**CITY OF SANDUSKY
DEPARTMENT OF PUBLIC WORKS
JACKSON STREET PIER REDEVELOPMENT DESIGN-BUILD PROJECT
BID FORM-DATED APRIL 18, 2018
REVISED ADDENDUM 4 - DATED MAY 31, 2018**

Additional Notes: Please review the attached complete BU#3B Ticket Booth & Restroom Renovations drawing set for final approval. The following approval letters and drawings have been included:

JACKSON STREET PIER BU-3B Drawing Set Publish Dates as Noted							
Item #	Reviewer	Review Comment for BU#3B Ticket Booth and Restroom (drawing date)	OHM Disposition of Review Comment	City Arch. Disposition of Review Comment	Donley's Disposition of Review Comment	Cost Impact	Accept / Reject
1	KS Associates / Karpinski	Sheet E04 (10/25/19): Restroom TH2: All receptacles in restroom are to be GFCI. The outlet at the homerun is not GFCI.	(11/18/19) Concured. Plan updated	Accepted			IQM Accept 11/22/19
2	KS Associates / Karpinski	Sheet E04 (10/25/19): Restroom exhaust fan is circuited as 120 volt but the HVAC schedule has 208 volt. How is this fan to be controlled since it is an independent circuit from the lights?	(11/18/19) See diagram 1 sheet E05. Circuit should be PP1-1,3	Accepted			IQM Accept 11/22/19
3	KS Associates / K

1 DRAIN WASTE VENT PLAN
1/4" = 1'-0"

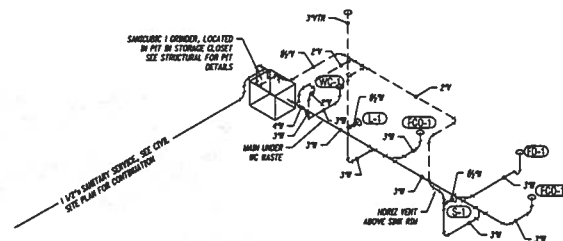
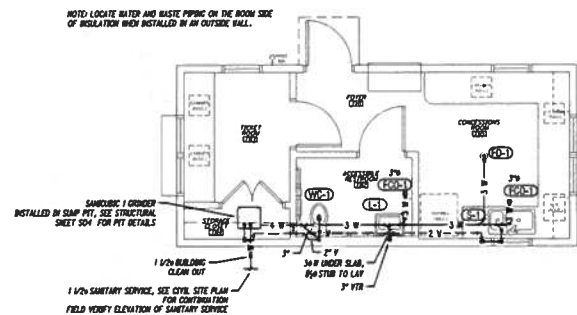
11	KS Associates / Karpinski	Sheet P03: WC-1 is not vented properly. OPC 915: It can't be a combination waste and vent because it receives waste from a water closet and discharge from a food waste disposer. OPC 912: It can't be a wet vent because it receives waste from outside the bathroom group.	(11/18/19) Added vent. (11-22-19) We concur. Diagram updated.	Vent added is not a fixture vent. It is connected to the main. Suggest running the sanitary from the water closet towards the south with a fixture vent off the top of the sanitary within the wall. Then connecting the sanitary from the water closet to the sanitary main.			IQM Accept 11/22/19
12	KS Associates / Karpinski	Sheet P03: Is water pressure adequate to serve a flush valve water closet with a 1.6 gallon per flush rating through a 1" domestic water main?	(11/18/19) We assumed yes. We can change to a tank toilet if desired.	It is the Engineer of Record's responsibility to determine if the water pressure is adequate for the system as designed. If pressure is not adequate, suggest changing to a tank type water closet if acceptable by Owner.			IQM Accept 11/22/19

PROPOSED POWER PLAN

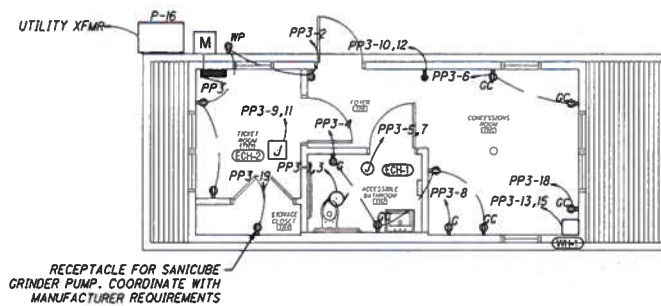
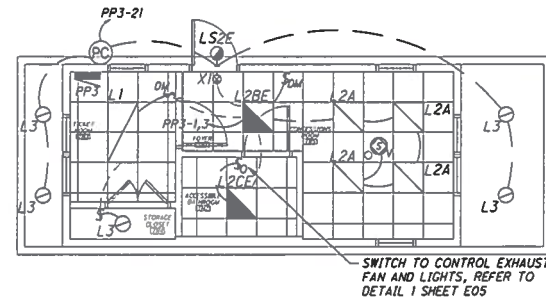
4	KS Associates / Karpinski	Sheet E05 (10/25/19): Panel PP3 for the Ticket Booth is shown as 3 phase. The underground utility BU2 has this feeder as single phase. Verify the incoming power to confirm the single phase is correct. If it is, update the loading (in Amps) to reflect the higher amps.	(11/18/19) Coordinated with Firelands - to provide 3ø panel	The work will revise the breaker and wire size in phase BU2 that was previously approved. This is acceptable.			IQM Accept 11/22/19
5	KS Associates / Karpinski	Sheet E06 (10/25/19): Restroom Lights type L1 Are Flat panel LED but the ceiling is existing. Not sure the ceiling is grid or gyp. Should this be vandal resistant construction?	(11/18/19) L1 can be surface mounted, surface mount kit part number added to fixture schedule. Vandal resistant is not required - owner preference	Accepted			IQM Accept 11/22/19
6	KS Associates / Karpinski	Is a panic/hold-up alarm push button required for the concessions and ticket counters?	(11/18/19) Not required by code	Correct not required by code but a good practice if money is exchanged			IQM Accept 11/22/19

7	KS Associates / Karpinski	Is there a POS Server location required? If so, provide adequate rough-in.	(11/18/19) Yes, plan updated	Accepted			IQM Accept 11/22/19
8	KS Associates / Karpinski	Is video surveillance cameras required for this space?	(11/18/19) Not required by code	Correct not required by code but a good practice if money is exchanged			IQM Accept 11/22/19
9	KS Associates / Karpinski	Sheet P03: Suggest indicating required work for DF-1. Is an existing drinking fountain being removed? If not, stack diagram should be added.	(11/18/19) Existing restroom, don't have piping as built. Existing drinking fountain was removed at some point. (11-22-19) note added.	Suggest adding Note to describe Scope.			IQM Accept 11/22/19
10	KS Associates / Karpinski	Sheet P03: It's important that water and waste piping is located on the room side of the insulation when installed in an outside wall.	(11/18/19) Added note.	Accepted			IQM Accept 11/22/19
